Ninety-eighth session Geneva, 3–7 May 2010 Item 6 of the provisional agenda Regulation No. 46 (Devices for indirect vision)

Proposal for amendments to Regulation No. 46

Submitted by the expert from the United Kingdom of Great Britain and Northern Ireland*

Figures 8c and 8d: Additional field of vision at 1 m high

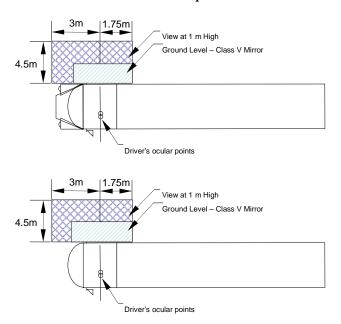
Insert new paragraphs 15.2.4.5.6. to 15.2.4.5.9. (including new Figures 8c, 8d and 8e), to read:

- "15.2.4.5.6. on the passenger side only, the field of vision shall also be such that the driver can see [part of] an object 1m high and 30cm in diameter which is outside the field defined in 15.2.4.5.1. to 15.2.4.5.4. but within the field bounded by the following vertical planes (see Figures 8c and 8d):

- 15.2.4.5.7. in the transverse direction, the parallel plane passing at a distance of 4.5 m in front of the plane mentioned in paragraph 15.2.4.5.1.
- 15.2.4.5.8. to the rear, the plane parallel to the vertical plane passing through the driver's ocular points and situated at a distance of 1.75 m behind that plane.

- 15.2.4.5.9. to the front, the plane parallel to the vertical plane passing through the driver's ocular points and situated at a distance of 3 m in front of that plane. This field of vision may be partially provided by a front mirror (see figure 8e).

- 15.2.4.5.10. In cases where the described field of vision prescribed in paragraphs 15.2.4.5.6. to 15.2.4.5.9. can be obtained without the use of devices for indirect vision then, in relation to these paragraphs, the installation of such devices is not required.
